Comal County Environmental Health OSSF Inspection Sheet

Permit of Authorization to Construct an On-Site Sewage Facility Permit Valid For One Year From Date Issued

Permit Number: 118148

6413 CHIMNEY ROCK CANYON LAKE, TX 78133

OSSF LAYOUT PLAN LOTS 46D AND 46E, CHIMNEY ROCK **EMERALD VALLEY** COMAL COUNTY, TEXAS

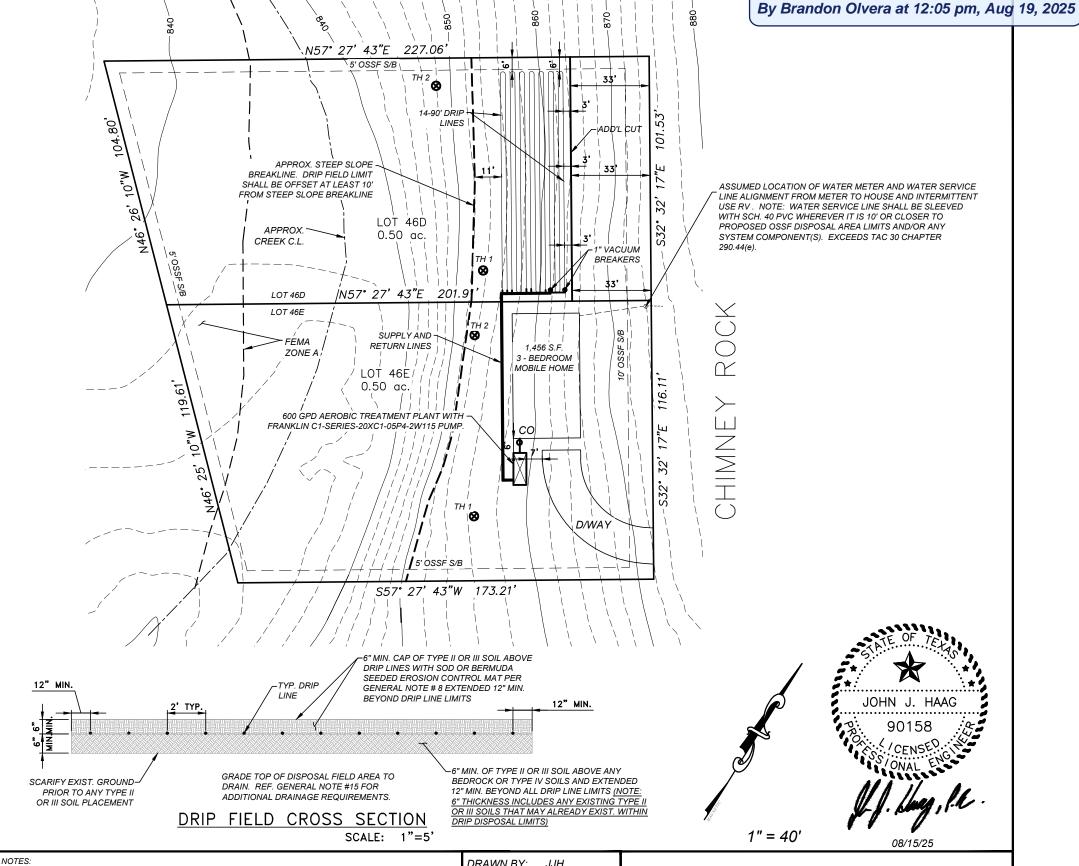
The square footage does not match the site plan. Are you purposing a 3456 sq.ft. home or a 1456 sq.ft. home?

Y. Provide a soil evaluation for the new lot the OSSF drip field is purposed.

- 4. Site Plan:
 - There is a 5 ft utility easement on all property lines.
 - i. 285.91(10) there is a 1-foot separation distance from sewer pipe with watertight joints and property lines.
 - b. 285.4(b)(2) OSSF crossing property lines.
 - Y. The owner or owner's agent must demonstrate that there is not adequate space to keep the system on a single lot.
 - If the above can apply, provide the crossing property lines affidavit.
- 6. Revise accordingly and resubmit.

Due to the topography on both lots (steep slopes and FEMA floodplain areas) and limited area for a habitable structure, it is necessary for the OSSF to utilize both lots.
